Re: City of Frisco Comments; May 22, 2012 Exide Technologies Revised Affected Property Assessment Report; Former Frisco Recycling Center;  
TCEQ Agreed Order Docket No. 2011-1712-IHW-E; IHW Permit No. HW-50206  
TCEQ SWR No. 30516; Customer No. CN600129779; Regulated Entity No. RN100218643;  
EPA ID No. TXD006451090; EPA Administrative Order on Consent RCRA 06-2012-0966

**City of Frisco Comments**  
**Exide Former Operating Facility**  
**Revised APAR**  
**August 29, 2014**

*Photographs taken of supersacks at former Exide facility during April 17, 2014 site visit.  
Note the white staining along flowpaths from the supersack storage area.*

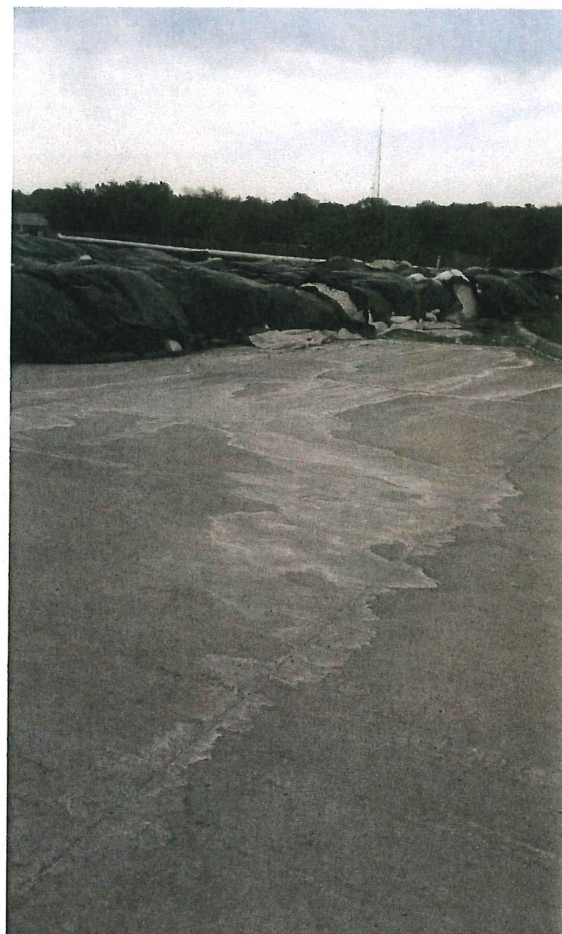
- 2) A "white crystalline substance" is repeatedly documented as occurring with contaminated soil at the FOF. Page 1-17 of the revised APAR states, "The historical releases generally have been associated with exposed slag, battery case fragments, or other process waste materials (e.g., white crystalline precipitate material identified on the exterior side of the Flood Wall during EPA and TCEQ site inspections)." It appears that the white crystalline substance or a similar material is leaking from supersacks containing waste materials from the deconstruction/demolition of the former processing area.

Discharge and remediation of this material must be addressed in the revised APAR since it is currently present at the FOF.
